ENVIRONMENTAL REVIEW TEAM REPORT

HOLLISWOOD

EAST GRANBY, CONNECTICUT

HOLLISWOOD
EAST GRANBY, CONNECTICUT
JULY, 1983

FIGURE 2 SIMPLIFIED SITE PLAN

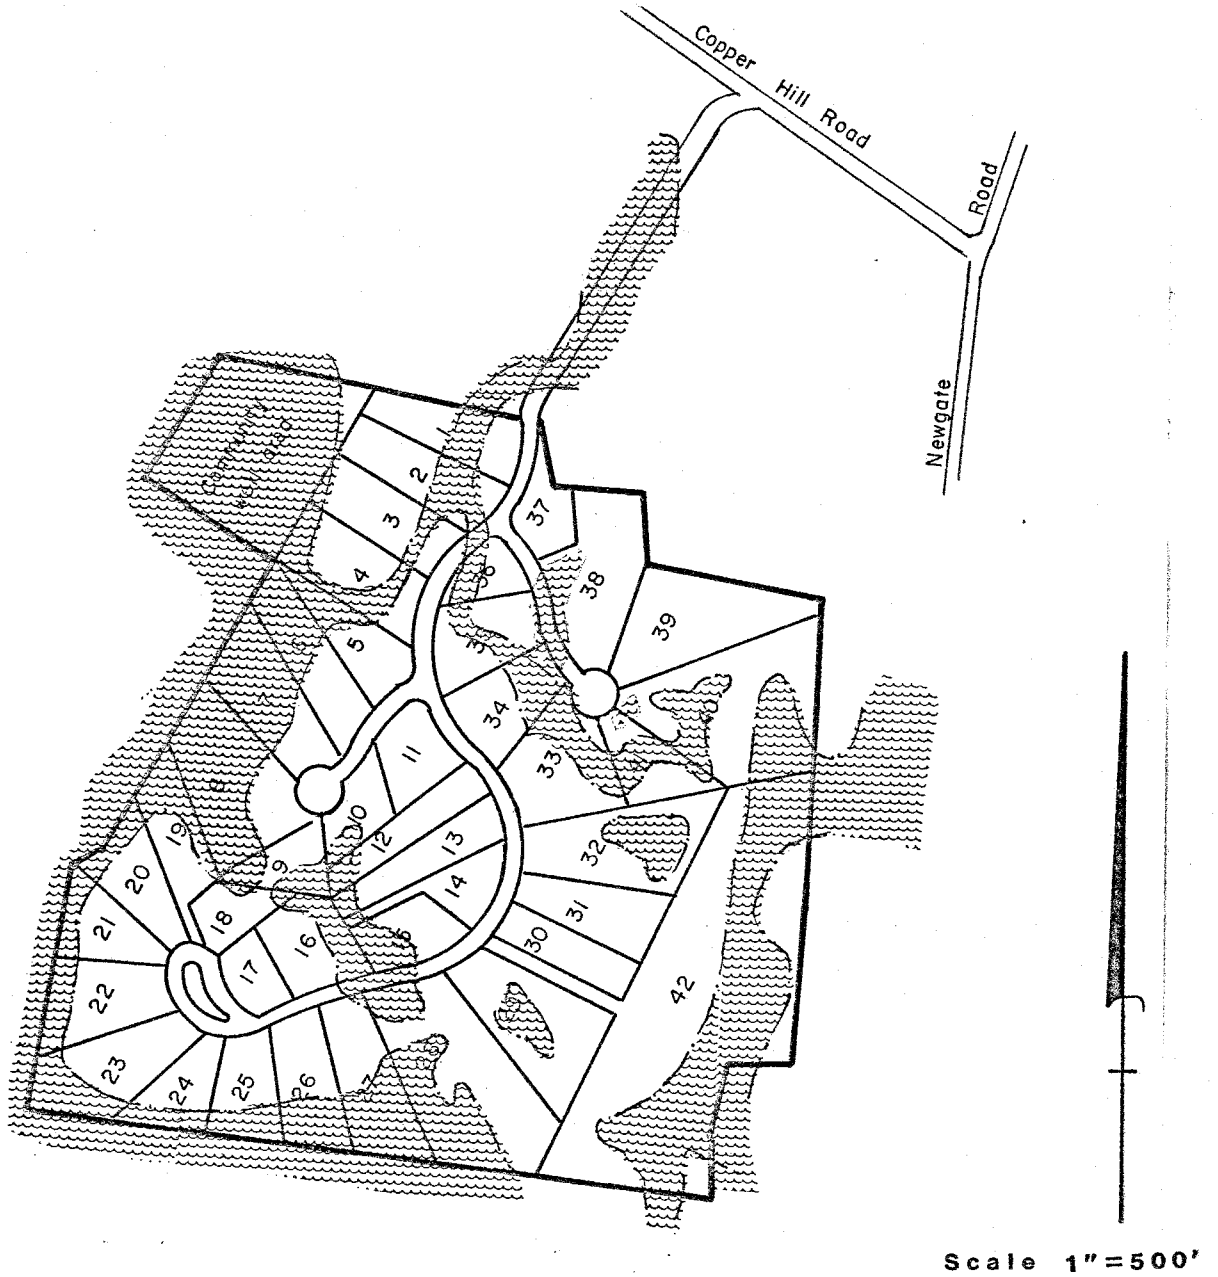
The proposed project calls for 42 lots of + 3/4 acre to + 9 acres in size (see Figure 2). An interior road network of + 4,500 feet would be constructed to service the project. The lots are proposed to be served by on-site septic systems and a community water supply.

As depicted on the site plan (revised 2/3/82) stormwater drainage emanating from the northwest portions of the site will be discharged either into a stream, which ultimately discharges into the wetland or directly into the wetland. Stormwater drainage throughout the remaining portions of the subdivision will flow either directly to the wetlands or into two proposed detention ponds and then into the wetlands. The ponds will be installed in the southern portions of the site. These ponds may also serve a sediment retention function. If sediment does accumulate in the pond, the material should be removed periodically. Proper maintenance of the retention pond will assure that the runoff storage capacity of the pond is not diminished.

Prior to subdivision approval, it is recommended that the applicant be required to submit detailed hydrological information on pre- and post-development runoff volumes and peak flows from the property. Estimates should be provided for a 10, 25, 50 and 100 year design storm. Detailed design specifications for all stormwater control facilities (including ponds) should also be submitted. All storm drain outlets should include a designed energy dissipator to help protect areas below the outlet from gulying.

none of these characteristics are evident in the proposed development plan for this site. Rather, the project appears to be an attempt to place a maximum number of lots on a sensitive site. Portions of many of the lots are wetland or under proposed ponds. Houses are crowded together in many areas on small and awkwardly shaped lots with no compensating common open space. Some lots on the eastern edge are under an existing high tension line with homes shown just at the minimum distance from the line.

Many portions of the site are buildable, but a different approach should be considered. If the concept is to be single-family homes, a larger lot size should be considered in certain areas to reflect the nature of the site and the character of the surrounding area. In particular, lots 7, 8, 9, 12, 13, 14, and 27 should be considered for re-design. If clustering is done, a townhouse concept might be more appropriate. This could place all units on good soils and locations, and set aside both developable and wetland areas for common recreation space and natural area preservation.

As shown in Figure 2, access to the project would be provided by an interior road network of + 4,500 feet. The proposed single access will essentially create a long dead-end road which could prove problematic or dangerous in the event the roadway is ever blocked (e.g. fallen tree, traffic accident). While it would be desirable to create a second access to the site, this does not appear possible without acquiring additional land or an easement to additional land.

FIGURE 3 SURFICIAL GEOLOGY MAP

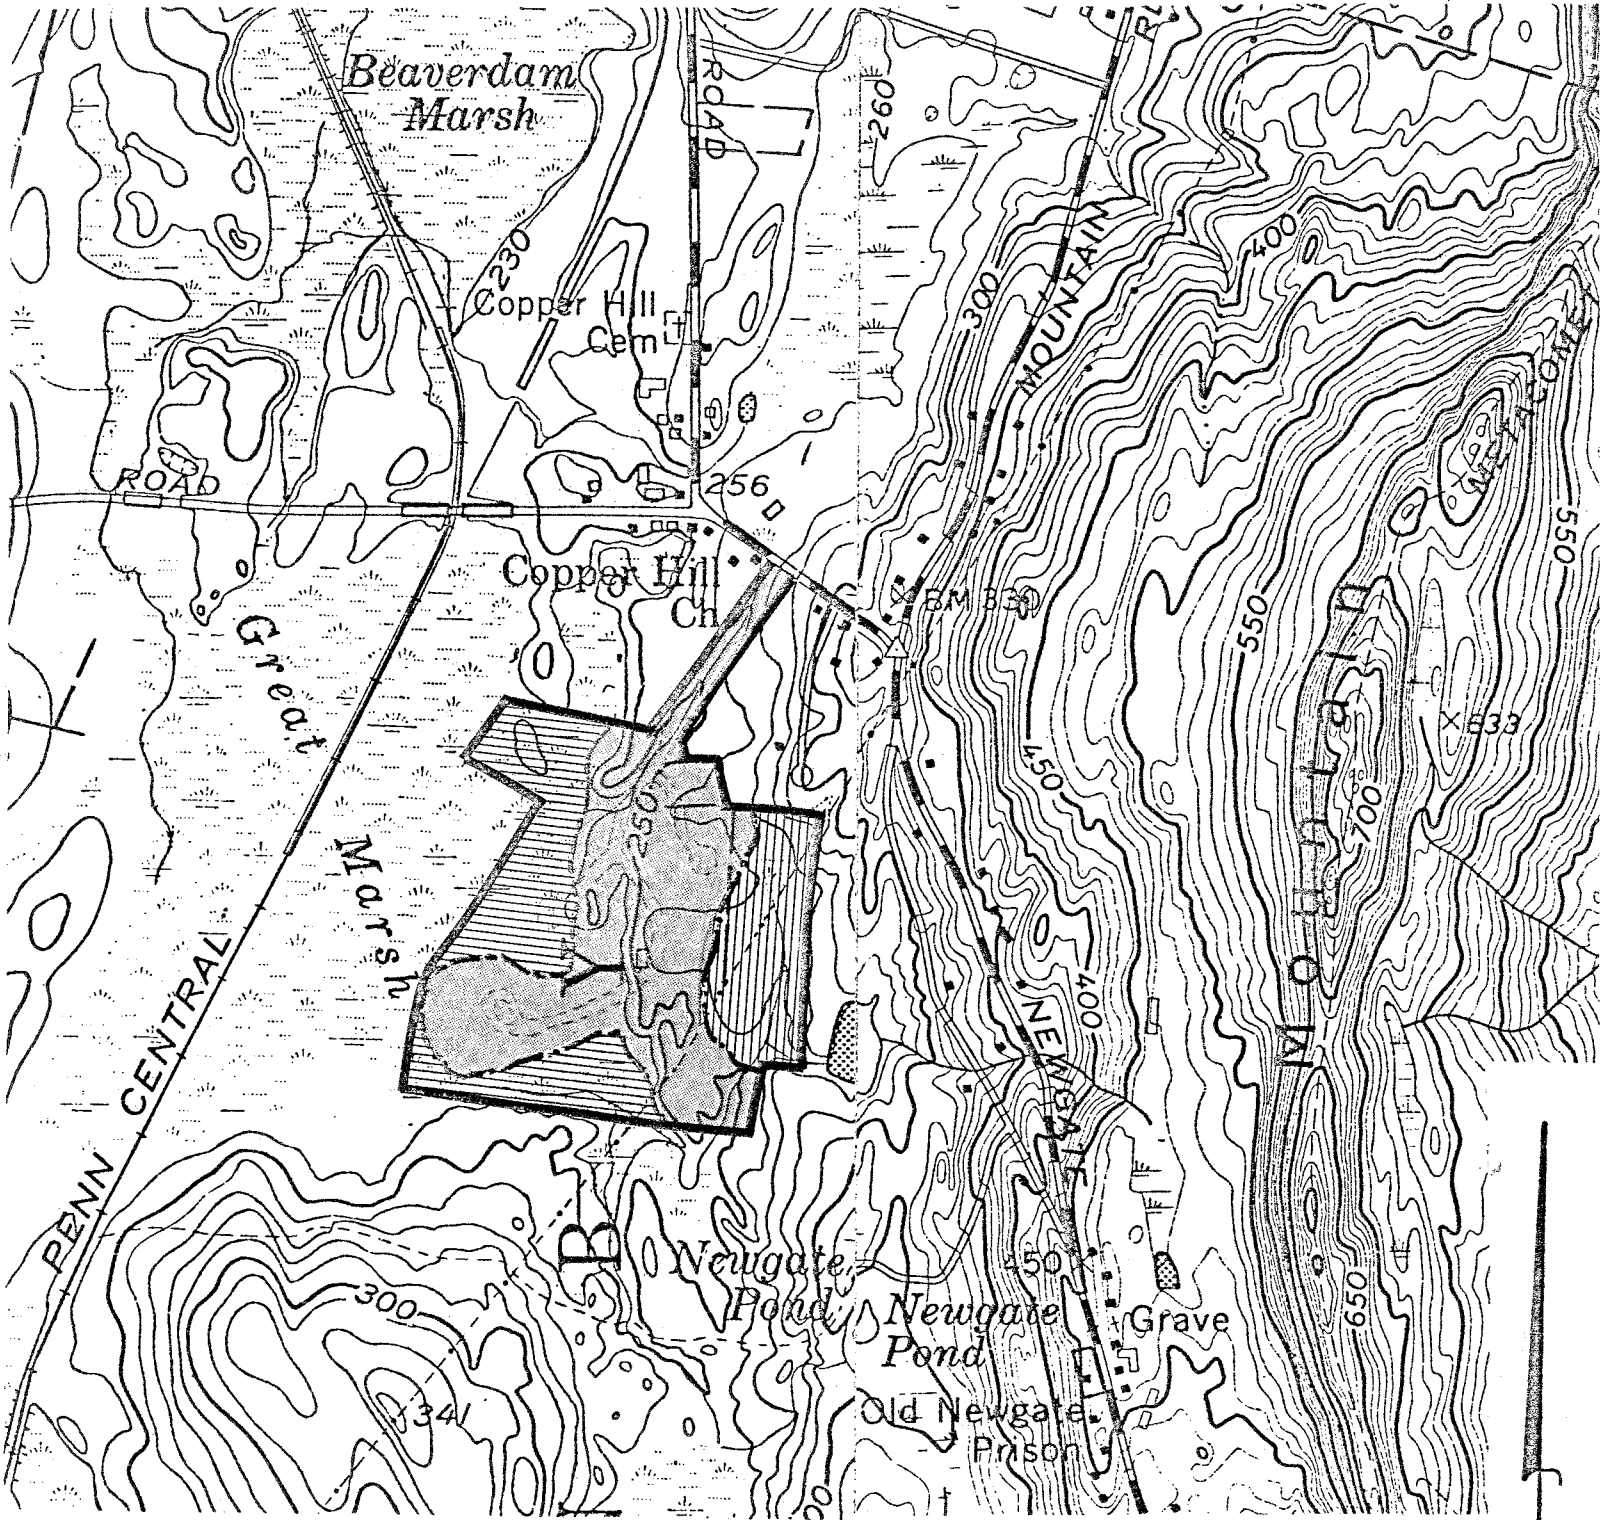
site may include: 1) the use of curtain drains, where possible, 2) proper surface grading and drainage and 3) the use of fill to elevate the septic system above the high ground water table. The thickness of till on the site is probably less than 10 feet.

Swamp deposits, which are found in the western and southern sections of the site, consist of decayed organic material (peat and muck) mixed with some silt, clay and sand. There is no information available to the Team on the thickness of these deposits, but it is likely that they are at least 10 feet thick. The swamp deposits are probably underlain by stratified drift deposits.

FIGURE 4 WATERSHED MAP

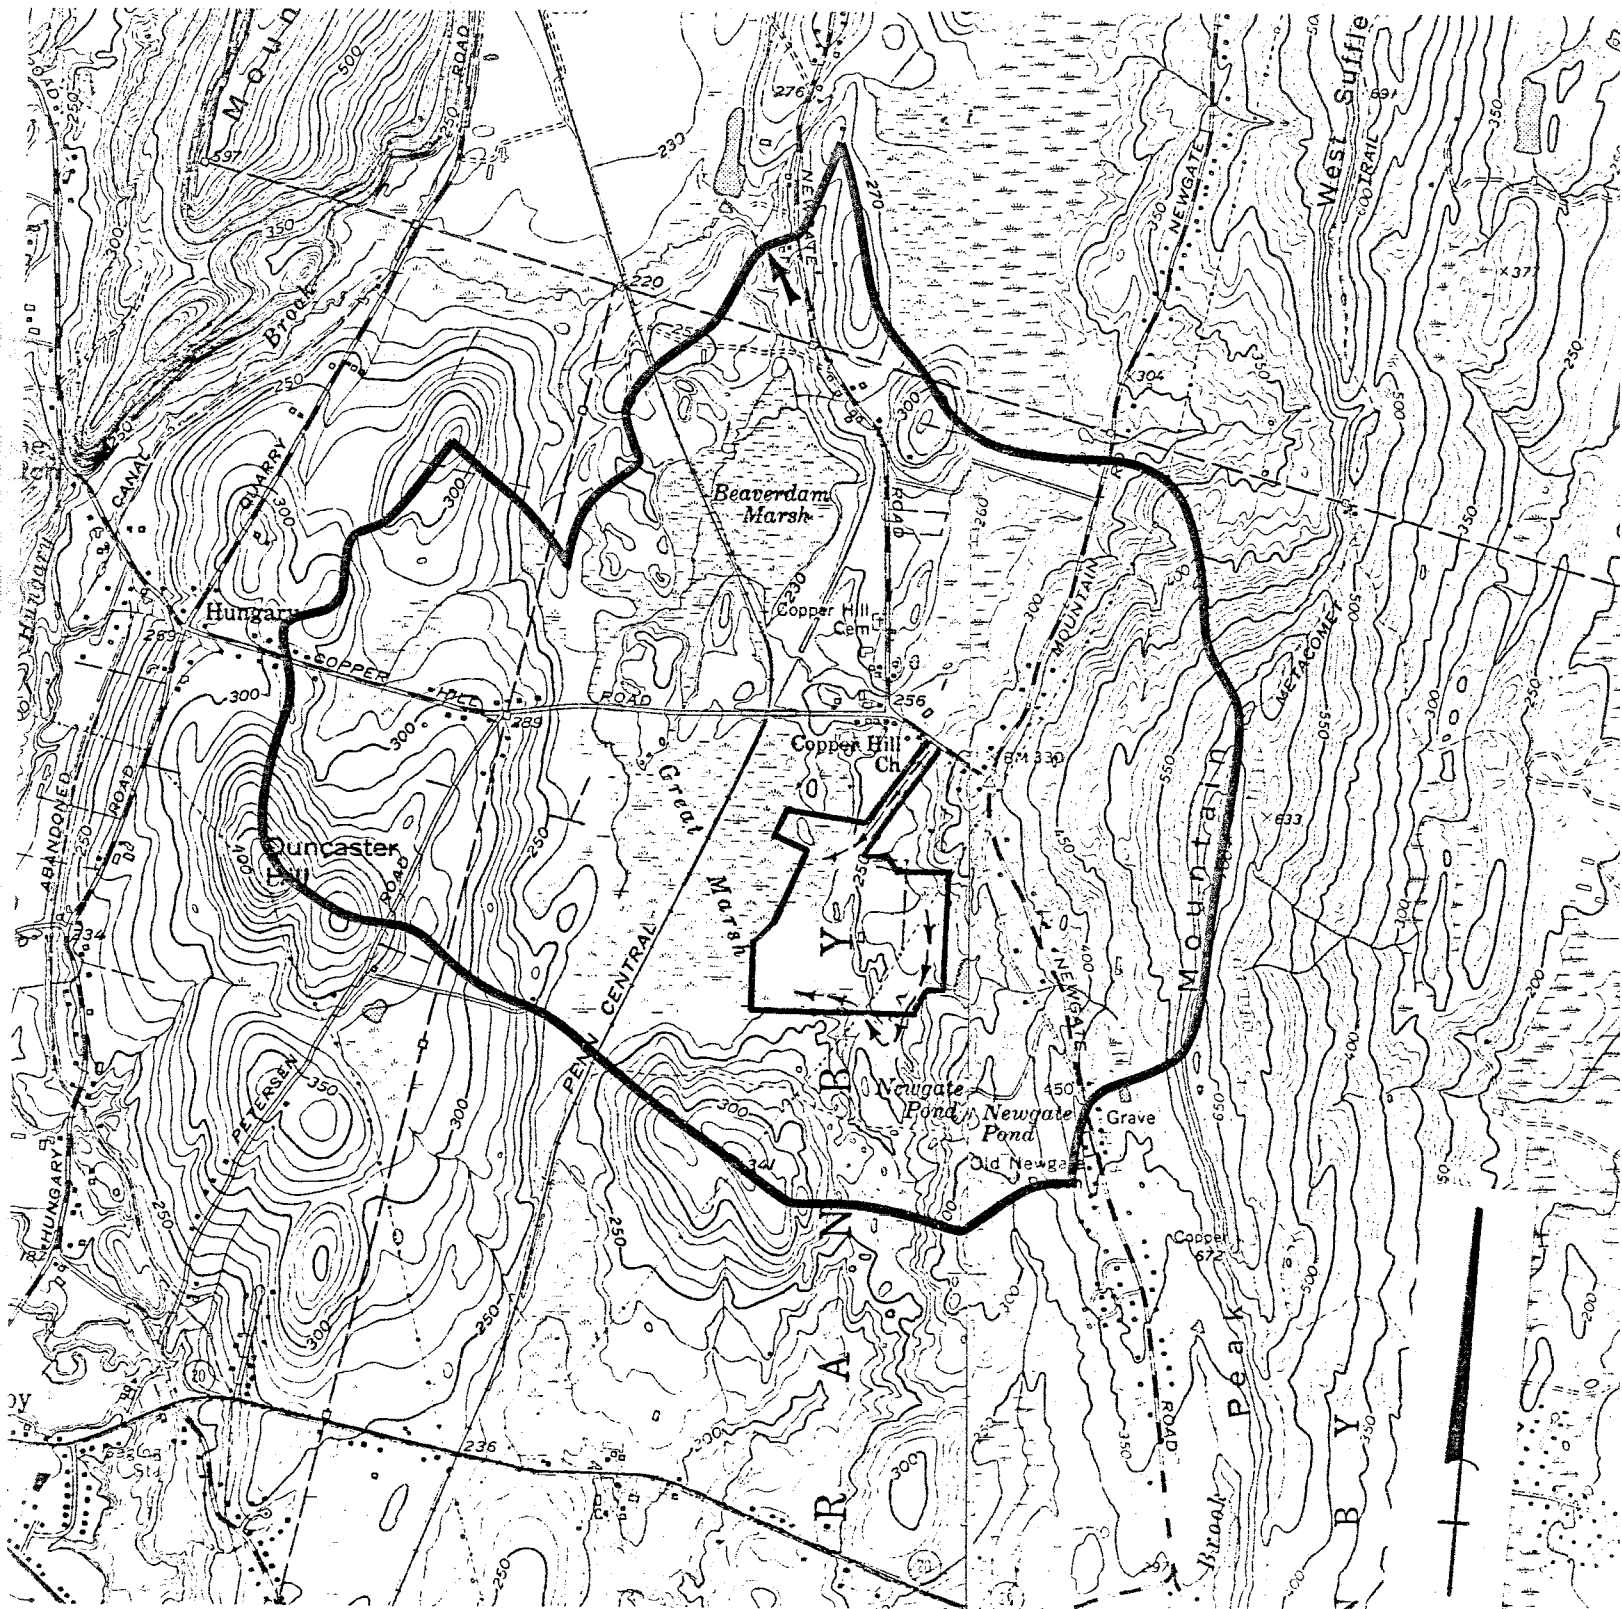
The Holliswood site lies within the watershed of Beaverdam Marsh Creek, a tributary of Hungary Brook. The size of the watershed is relatively small, about 1,472 acres or \pm 2.3 square miles (see Figure 4).

Development of the site as planned can be expected to increase the amount of runoff from the site for a given rainfall amount and to thereby increase peak flows of streams into the wetland and the proposed detention ponds in the southern portion of the property. These increases would be caused by removal of vegetation, compaction of soil during the construction phase, and creation of impervious surfaces such as roofs, driveways, and roads.

FIGURE 5 VEGETATION TYPE MAP

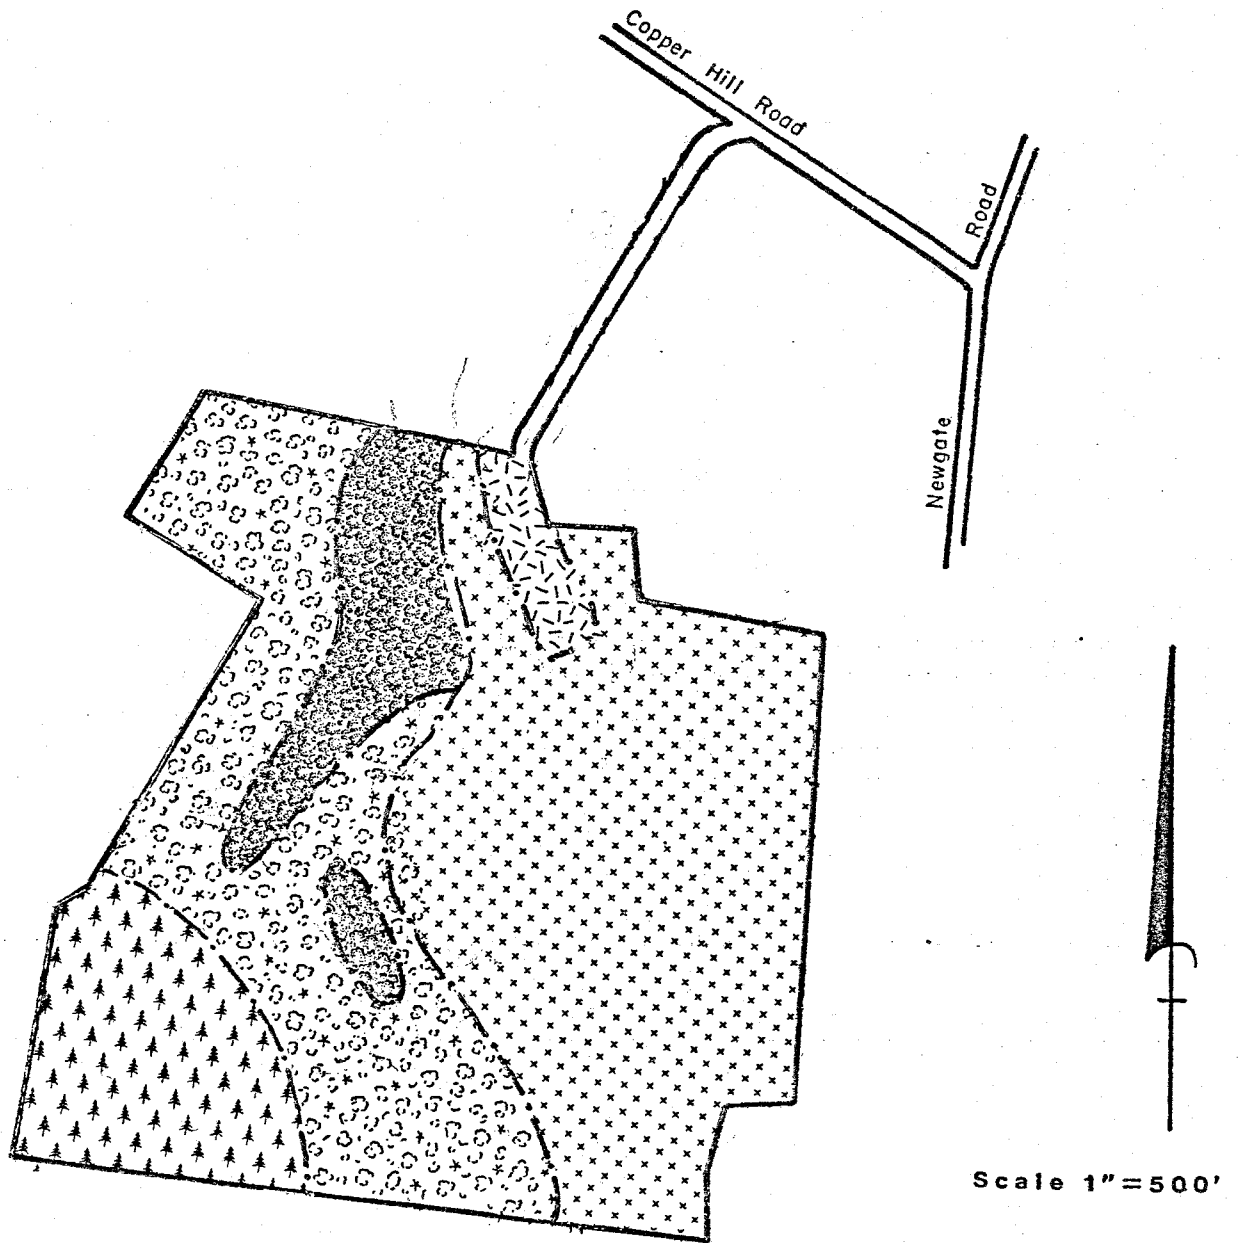
Vegetation Type 5 could be a problem to prospective home buyers. At present most of the coniferous trees are heavily infected with a variety of insect and disease related problems. Some of these problems may remain just aesthetic in nature but mortality is a possibility in heavily infected stands. Most of the Douglas fir has a problem with needle cast (Rhabdocline) and is serving as the alternate host for Cooley spruce gall aphid. The blue spruce (the other alternate) is laden with galls. Some of the Norway spruce and most of the white spruce is also covered with galls from the eastern spruce gall aphid.

In the opinion of the Team's Forester, the vegetation in Type 5 should be removed, due to the above described insect and disease problems. This area could be nicely landscaped with new varieties.
